**Value Engineering Study
Final Report**

Leavenworth National Fish Hatchery Surface Water Supply

Columbia Basin Project, Washington

July 25, 2012

Figure 3-1. New Clean-Out Valve

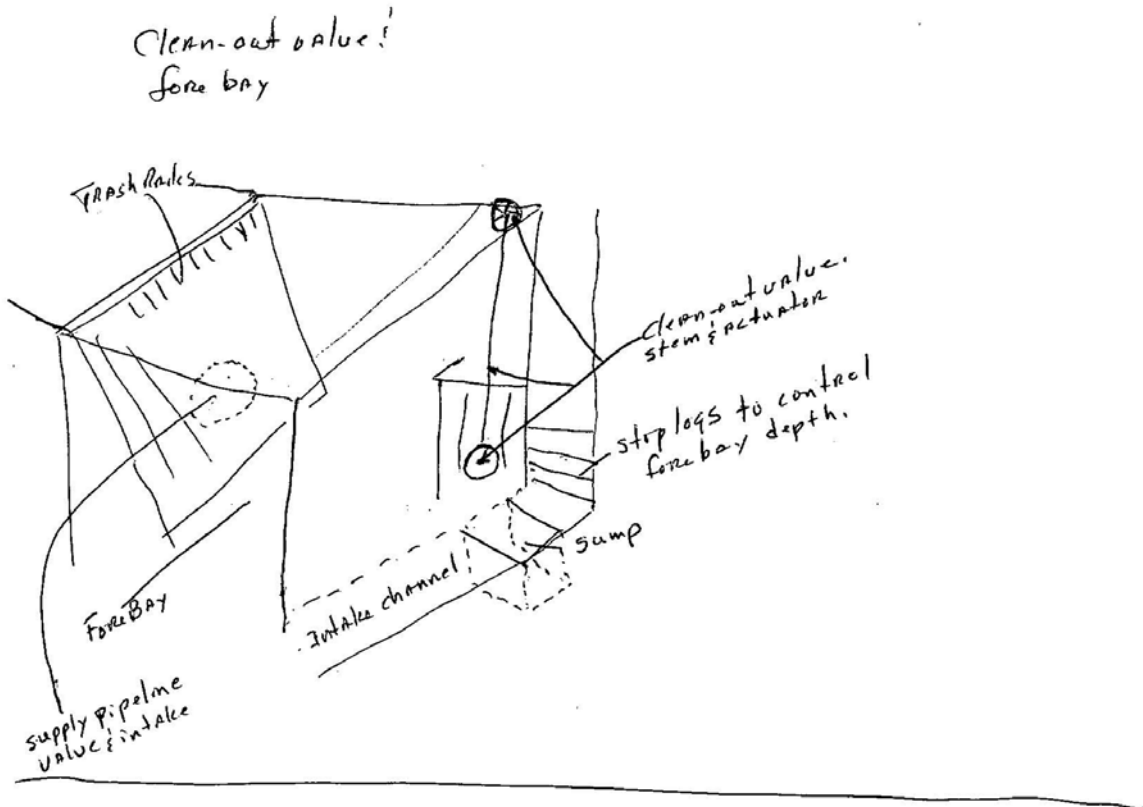
- Proposal Description: This is a personnel safety issue. Over time the valve stem has been bent, straightened, re-bent and the stem has fatigued to the point that it bends more easily each time some debris becomes stuck in the area of operation causing improper operation. At present, when the water conveyance channel to the intake structure fills with sediment, we have to flush the sediment through the channel in the intake structure by shutting the valve to the supply pipeline and removing dam boards we use to control the amount of water going to the supply pipeline forebay to allow water to flush sediment freely through the channel on downstream. In this operation with the clean-out valve closed, the sump in the bottom of the channel that directs water to the supply pipeline forebay fills with sediment if we don't open the clean-out valve. The forebay is approximately 10' deep and a ladder is used to access it to clean out the sediment blockage, usually two crew members with shovels. When the sediment blockage is freed, the forebay fills quickly and presents a dangerous situation with crew members scrambling up the ladder to escape the in rushing water. It is imperative that this be addressed immediately.

- Critical Items to Consider: To have the capability to de-water the delivery channel and the intake structure to install a new valve, stem, and actuator, channels for stop logs (dam boards) must be installed on the upstream face of the concrete structure that contains the trashrack next to the fish ladder and diversion dam. Currently the sediment blockage is relied upon to hold while the forebay is de-watered. Relying on the blockage to accomplish any work done on the valve creates the risk of injury. Replacement of the valve and installation of stoplogs will enhance the safety of the employees.

- Ways to Implement: The slide gate itself may not have to be replaced, but complete replacement would be ideal. At the least, the valve stem needs to be replaced and a valve stem support attached to the wall to maintain the integrity of the valve stem by preventing bending and maintaining smoother operation. The cost for the stoplogs is an approximation and the costs for the clean-out valve replacement or repair were done by Five Rivers Construction in the spring of 2011.

Figure 6B-1. HDPE Pipe Trench with CLSM

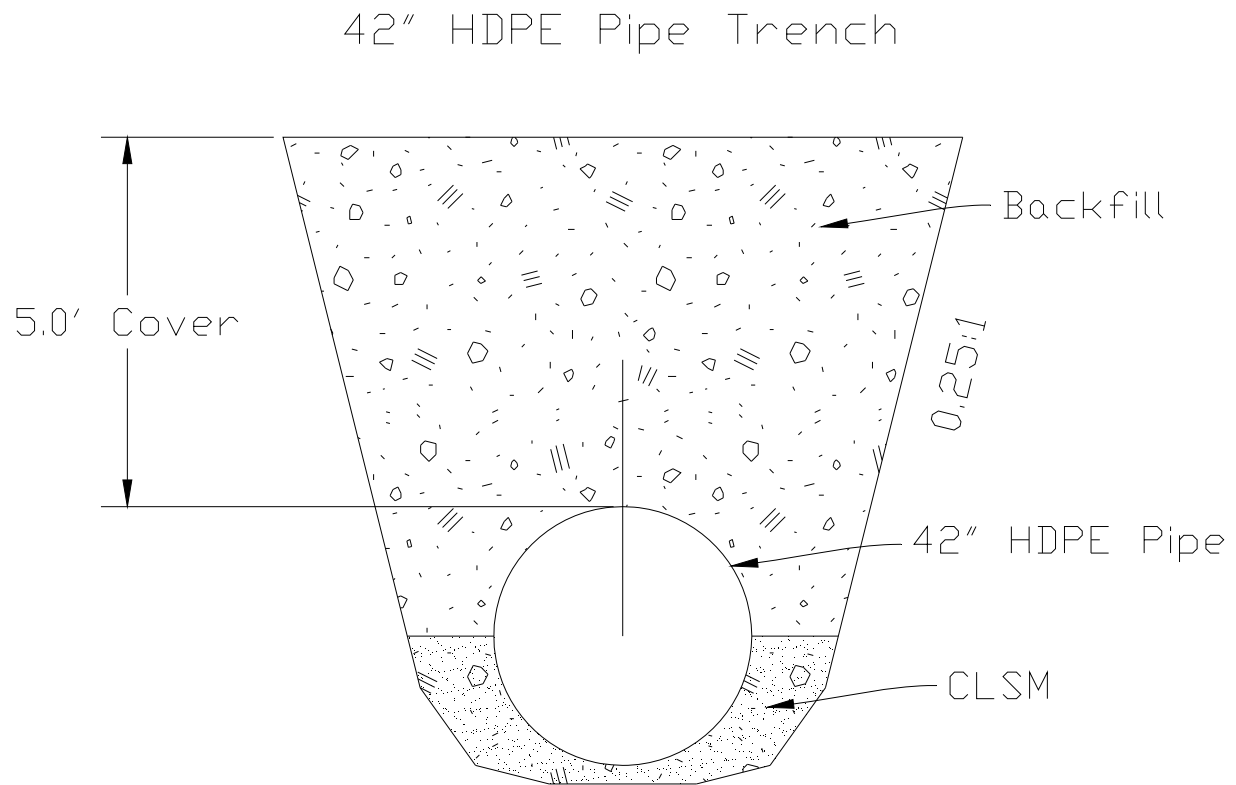
- Proposal Description: Install 42" HDPE Pipe (1300 LF) from intake to COIC bifurcation. This concept is to replace 1300 LF of existing pipe from the intake structure to the bifurcation. This section of pipe is considered to be in poorer condition than the rest of the pipe, possibly as a result of the sediment and frazil ice intercepted from the nearby intake structure. This option could also be considered as modification of the proposed Jacobs engineering design (2004).

- Critical Items to Consider: By using Controlled Low Strength Material (CLSM) as bedding and embedment in this location, sufficient support for flexible pipe such as HDPE would be provided. CLSM could be compacted with vibratory stingers vs. hand compaction necessary for other embedment materials. In addition, HDPE material is corrosion resistant and does not have the problem of ductile iron pipe (DIP) which is the concern of the plastic bag covering the pipe being torn during installation. This plastic bag provides the corrosion resistance for DIP.

- Ways to Implement: Excavate and remove existing pipe, install new 42" HDPE pipe with CLSM. Evaluate keeping existing pipeline in operation during installation of new HDPE pipe and minimize temporary water supply.
